Document 00 20 00 - Addendum No. 1

DATE: November 24, 2025

SE878D Meadow Lodge - HVAC and Roof Replacement
Indiana University Southeast
IU 20241304

M101

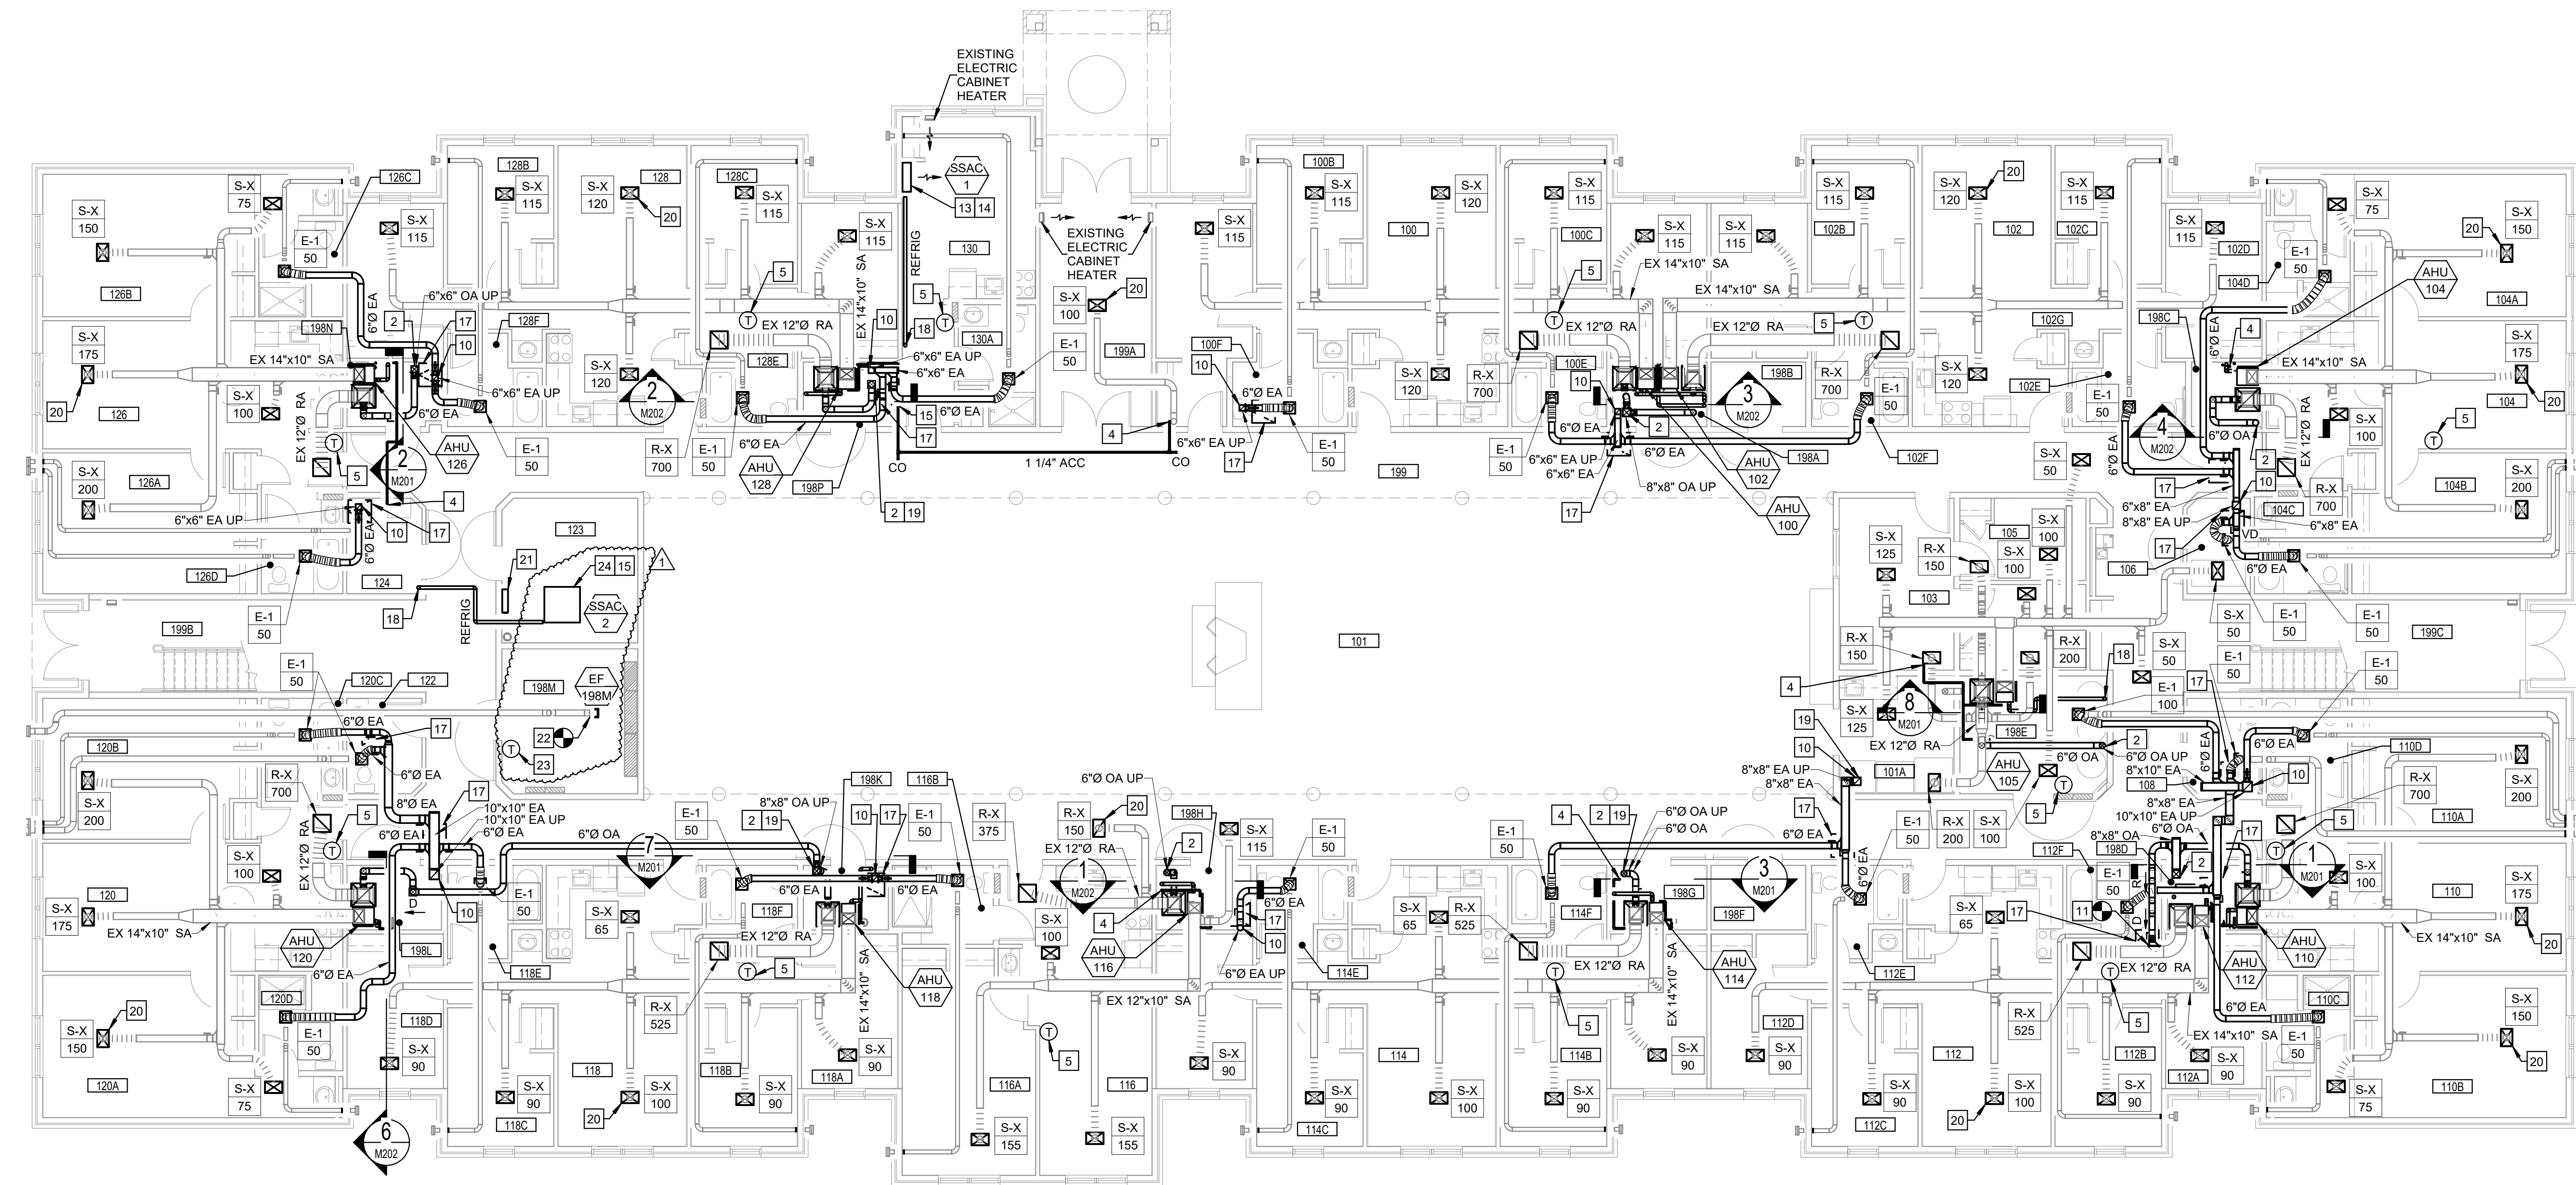
- a. Added Keyed Notes 22, 23, and 24 as indicated on the attached.
 - b. Replaced new exhaust grille and associated branch duct in Electrical Room 198M with new exhaust fan, EF-198M as indicated on the attached.

- c. Connected new EF-198M to existing exhaust air duct as indicated on the attached.
 - d. Modified Keyed Notes in room Electrical Room 198M as indicated on the attached.

- e. Modified Keyed Note 5 as indicated on the attached.
5. Sheet M401 – MECHANICAL SCHEDULES:
 - a. Updated “SPLIT SYSTEM SCHEDULE” as indicated on the attached.

- TEMPERATURE CONTROL PANEL. COORDINATE FINAL LOCATION WITH OWNER AND ENGINEER. LOCAL AREA NETWORK CONNECTION BY UNITS.
 - CONNECT EXISTING EXHAUST AIR DUCTWORK TO NEW EXHAUST FAN. INSTALL EXHAUST FAN PER MANUFACTURER'S INSTALLATION INSTRUCTIONS.

- PROVIDE NEW LINE VOLTAGE THERMOSTAT. CONTRACTOR TO CONNECT EXISTING WIRING TO NEW THERMOSTAT AND EXHAUST FAN AS REQUIRED FOR NEW INSTALLATION.
 - MOUNT SPLIT SYSTEM AIR CONDITIONER, EXPOSED BELOW EXISTING GYP CEILING, AND TIGHT TO EXISTING GYP CEILING. INSTALL SPLIT SYSTEM AIR CONDITIONER PER MANUFACTURER'S INSTALLATION INSTRUCTIONS.

M601

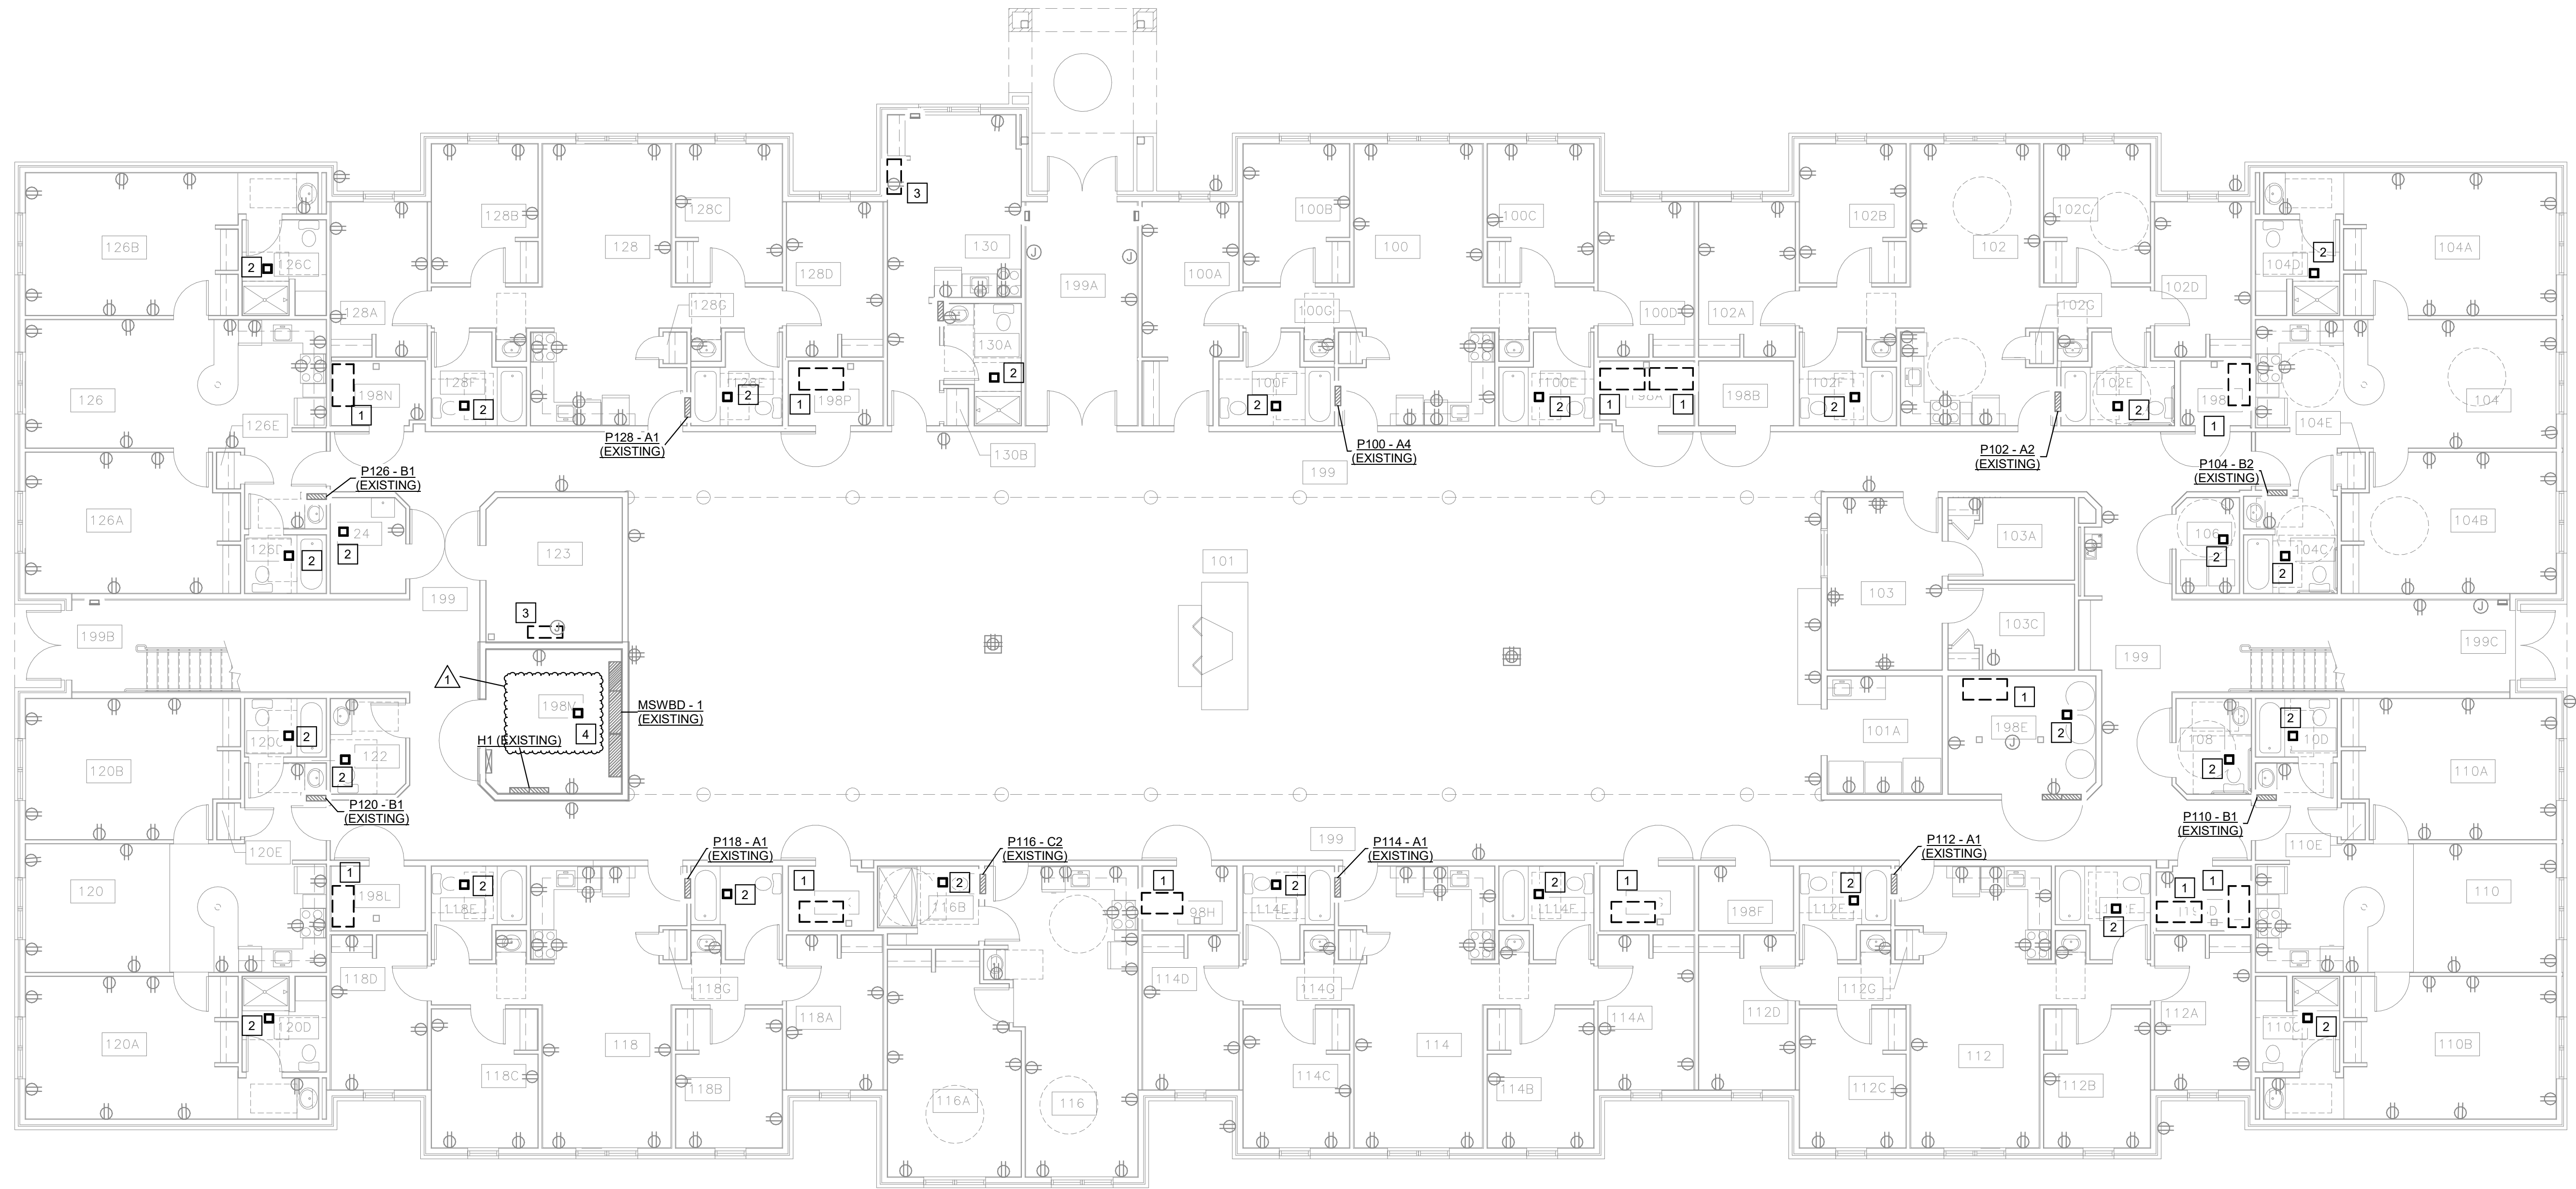
6. Sheet M601 – AIRFLOW DIAGRAM:
 - a. Updated “ERU-1 AIRFLOW DIAGRAM” as indicated on the attached.
7. Sheet ED301 – FIRST FLOOR ELECTRICAL DEMOLITION PLAN – POWER:
